Odell's House Mitigation Project

Johnston County, North Carolina

Re: NCIRT Review and USACE Approval of the NCDMS Odell's House Mitigation Site / Johnston Co./ SAW-2018-00431/ NCDMS Project # 100041

RE: RE: WLS Responses to NCIRT 30-day Review Comments Regarding Task 3 Submittal, Final Mitigation Plan Approval for Odell's House Mitigation Project, USACE AID# SAW-2018-00431, NCDEQ DMS Full-Delivery Project ID #100041, Contract #7420, Neuse River Basin, Cataloging Unit 03020201, Johnston County, NC

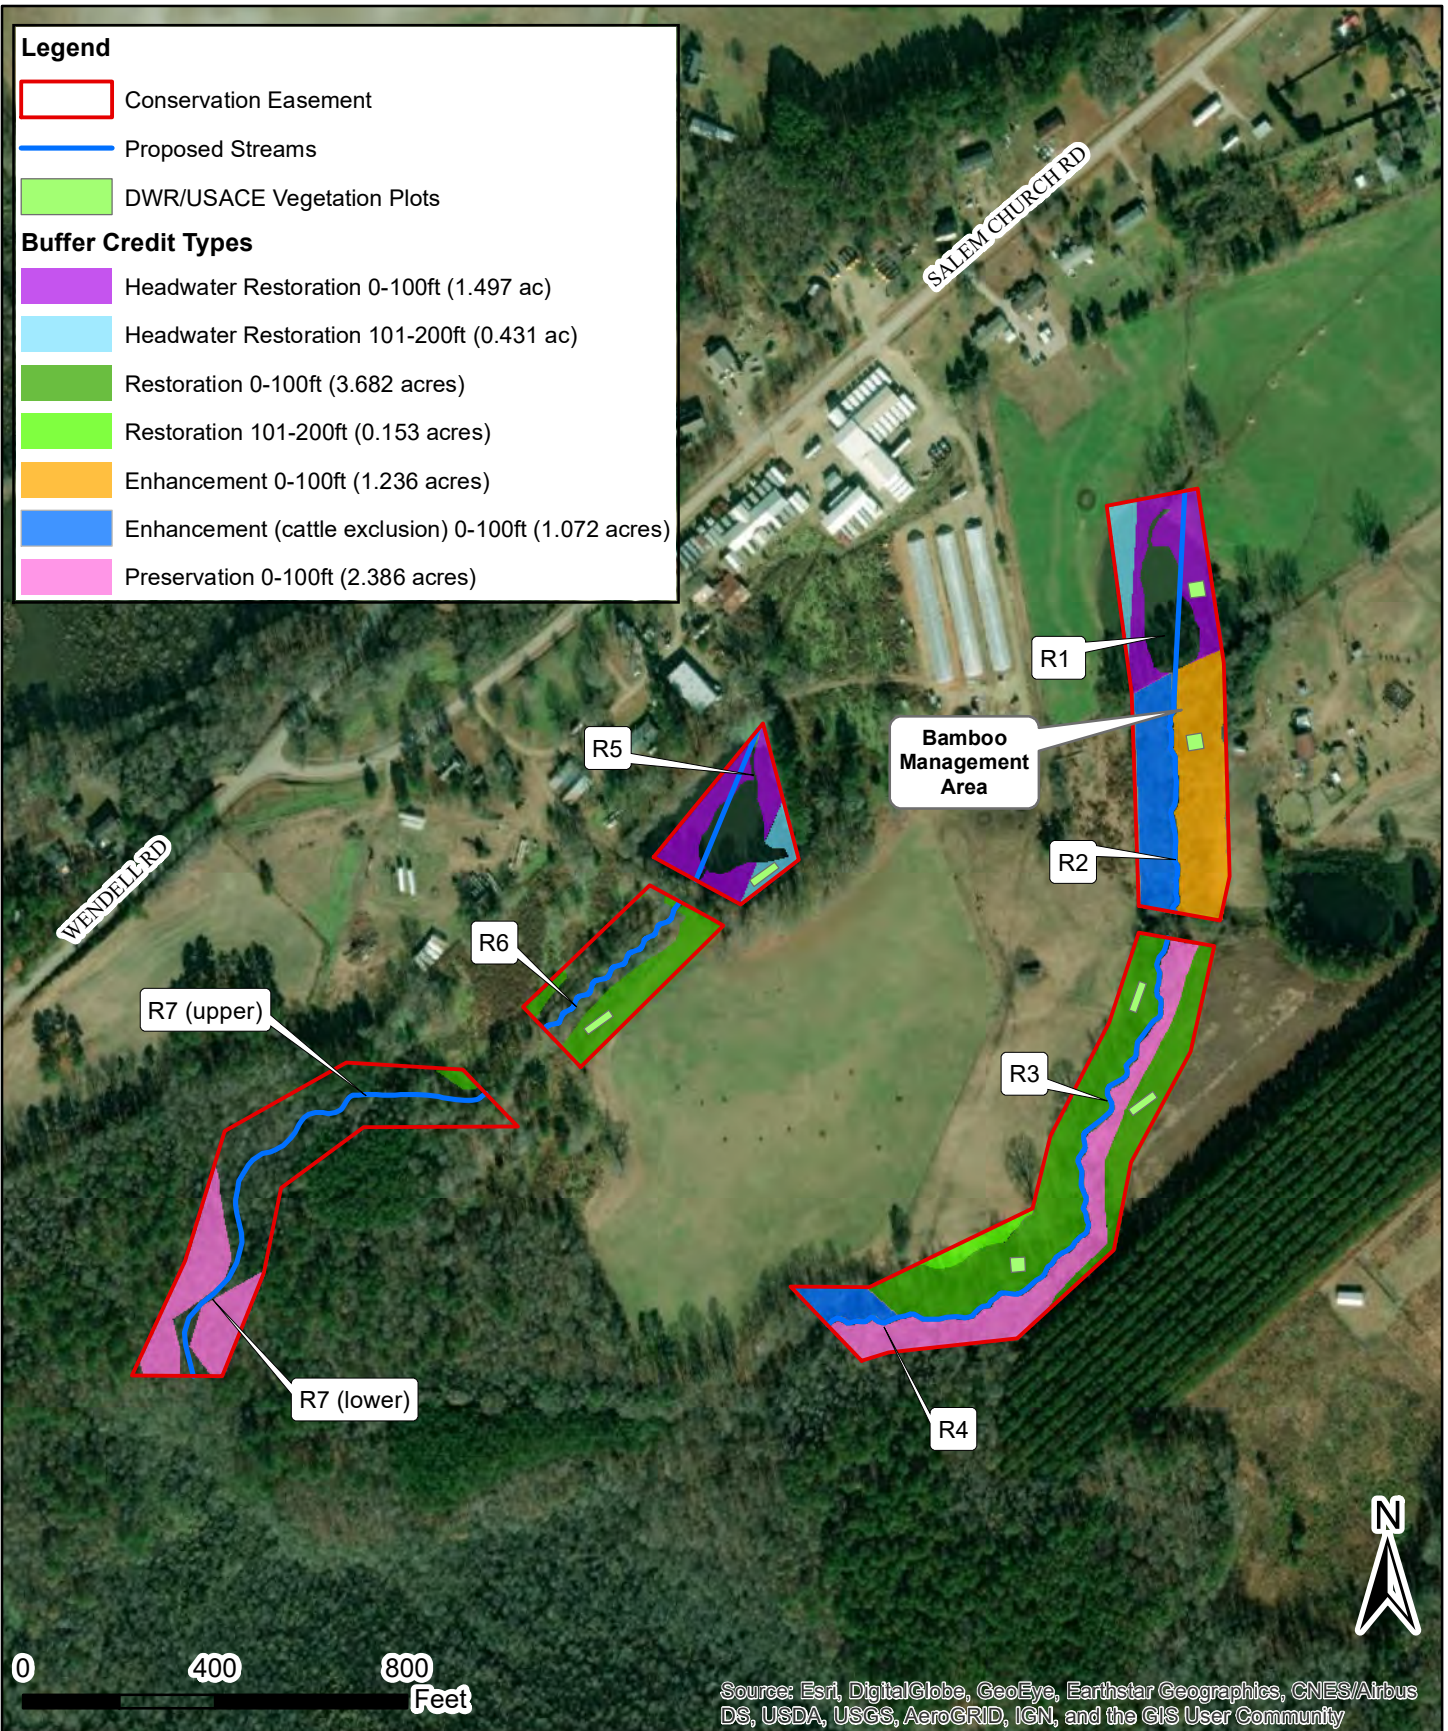
Figure 8:

38. I'd add "Bamboo Management Area" here. Response: The bamboo management area has been called out on Figure 8.

39. Add a plot to R1. The data in plots along both R1 and R5 will be performed for 7 years, not 5. Response: A vegetation plot has been added to R1 and can be seen on Figure 8.
